Indiana Residential Code

2005 Edition
Title 675 IAC 14-4.3

Rule 4.3. Indiana Residential Code

FIGURE R502.8
CUTTING, NOTCHING AND DRILLING

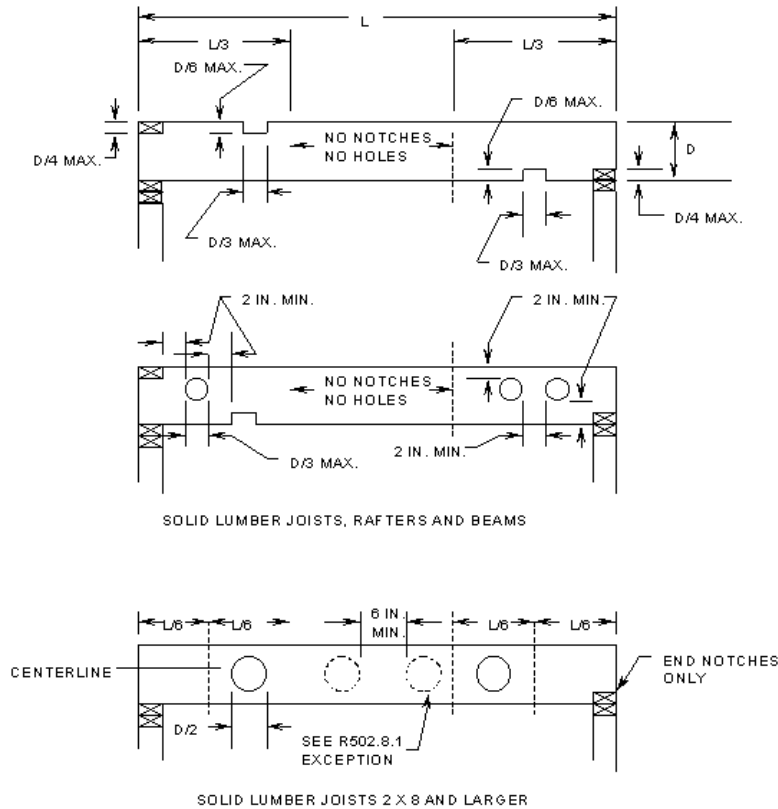
Sec. 88. Delete FIGURE R502.8 and substitute as follows: FIGURE R502.8:

FIGURE R602.6(2)
NOTCHING AND BORED HOLE LIMITATIONS FOR INTERIOR NONBEARING WALLS

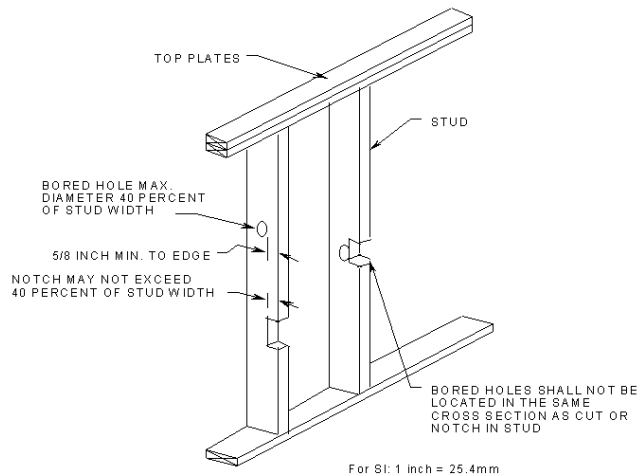
Sec. 95. Delete FIGURE R602.6(2) and insert FIGURE R602.6(2) to read as follows:

FIGURE R602.10.5(2)
GARAGE DOOR BRACED WALL PANEL FOR USE WITH CONTINUOUSLY SHEATHED WALLS

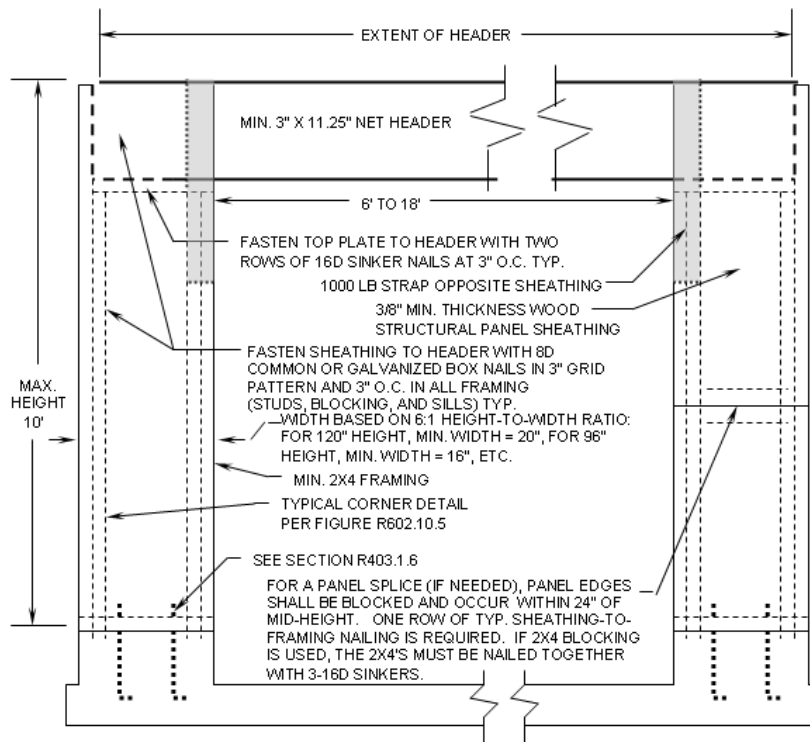
(4) Add FIGURE R602.10.5(2) to read as follows:

FIGURE R703.7.6(2)

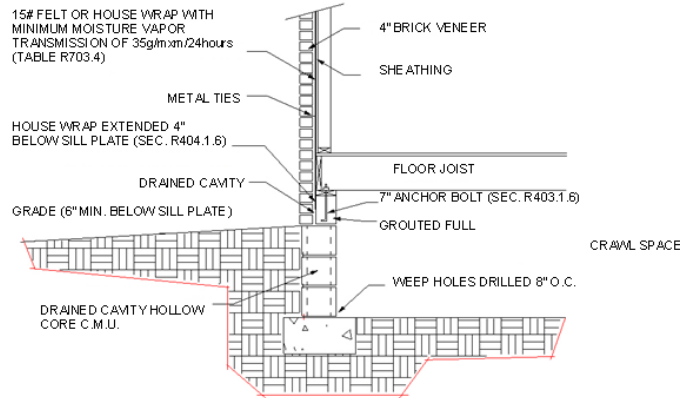
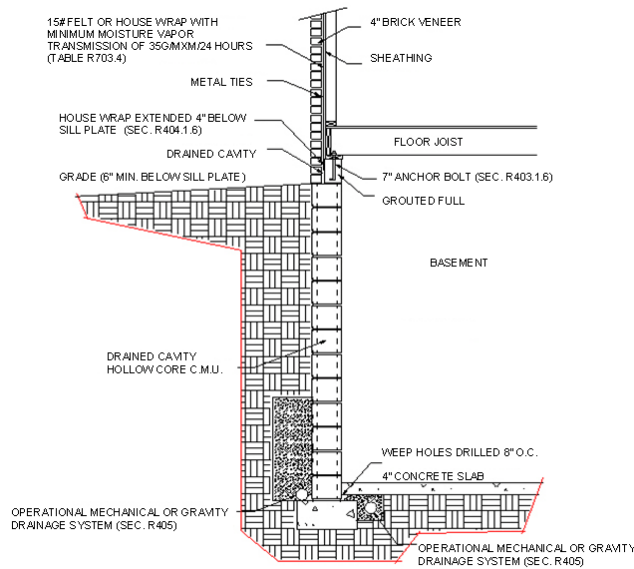
Sec. 121. Delete the title and text of SECTION R703.7.6 and substitute as follows: R703.7.6 Drained cavity. The ¾ inch (19 mm) air cavity shall be drained to the exterior of the structure at intervals of not more than 33 inches (838 mm) on center. Each drain shall be not less than 3/16 inch (4.8 mm) in diameter, located immediately above the flashing. For dwellings with crawl spaces, the air cavity may be drained as shown in FIGURE R703.7.6(1). For dwellings with basements, the air cavity may be drained as shown

in FIGURE R703.7.6(2).

FIGURE R1001.6
Chimney Termination

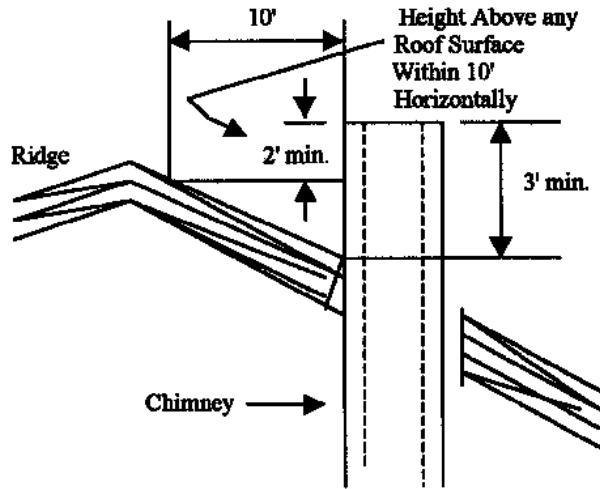
Sec. 135. Add FIGURE R1001.6 as follows:

FIGURE E3801.4.1

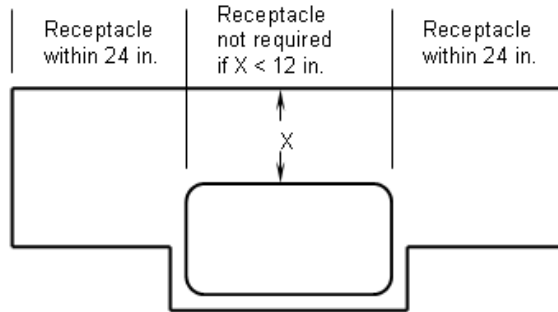
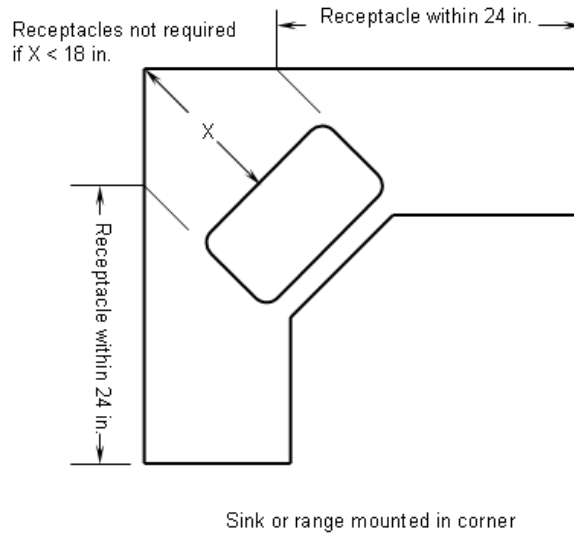
Sec. 229.5. (a) After SECTION E3801.4.1, add an exception to read as follows: Exception: Receptacle outlets shall not be required on a wall directly behind a range or sink in the installation described in FIGURE E3801.4.1.

(b) After SECTION E3801.4.1, add FIGURE E3801.4.1 as follows:
